ADDENDUM Transport Assessment**FROM Civil Designer, Technical Services, Orange City Council****DATE 01 October 2024****ON 277 Cargo Road – Gateway Alteration****Introduction**

Access to Cargo Road

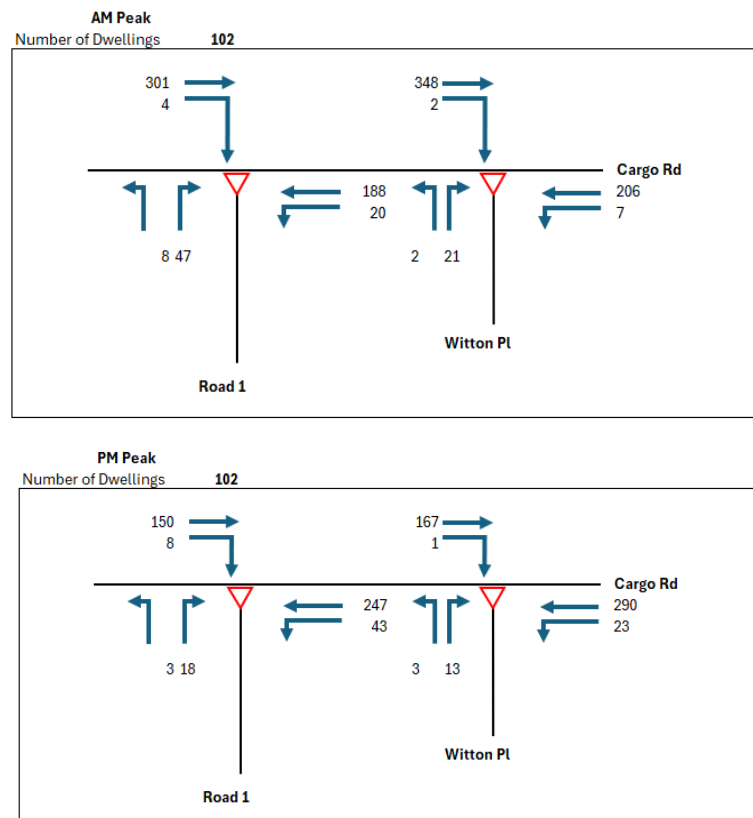
The Proposal continues to create 1 additional access road to Cargo Road. Secondary access has been identified as part of the proposal, however given there is no formal arrangement for creating the access, the Cargo Road access will apportion 100% of the traffic to that intersection for the allotments proposed under Stage 1.

Design Warrant for Cargo Road

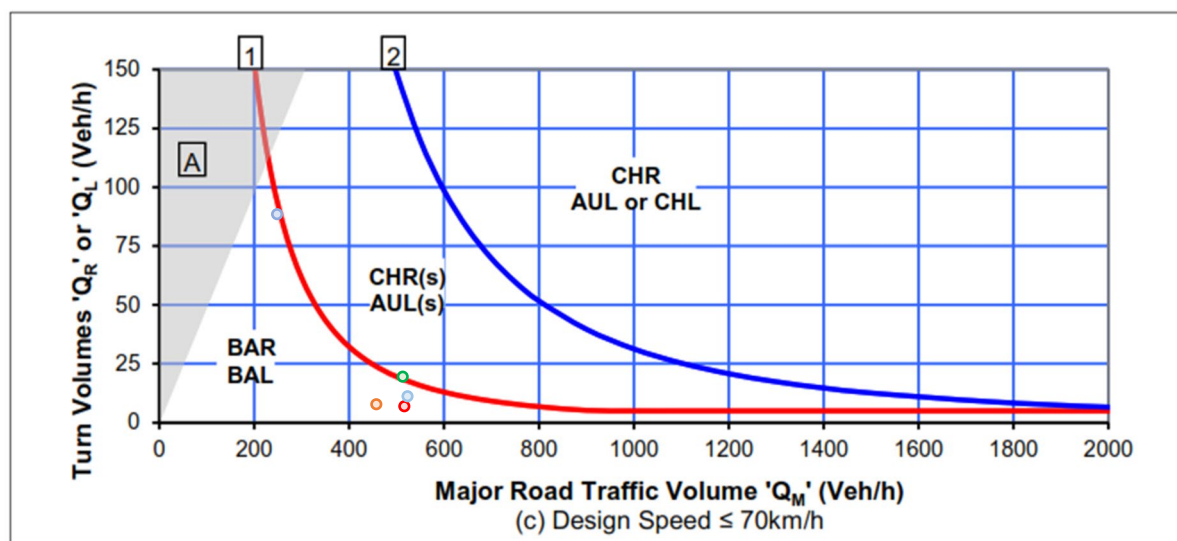
As shown an increase in yield for the current Planning Proposal to 102 lots still permits the treatment of the intersection of Cargo Road/Road 1 as a BAR/BAL treatment.

When evaluating the candidate area for 300 lots, the intersection is on the threshold for both the left treatment requiring an AUL(s) and the right turning treatment requiring a CHR(s) treatment, this should be further evaluated with any subsequent planning proposals.

- A BAR intersection is required with widening for right turn overtaking. An AUL (left turn lane) is appropriate, although not Austroad required.
- For any future proposals that increase the yield above 300 lots a CHR intersection will be required at Cargo Road, regardless of the secondary road as that intersection will accommodate all the right turns into the estate.
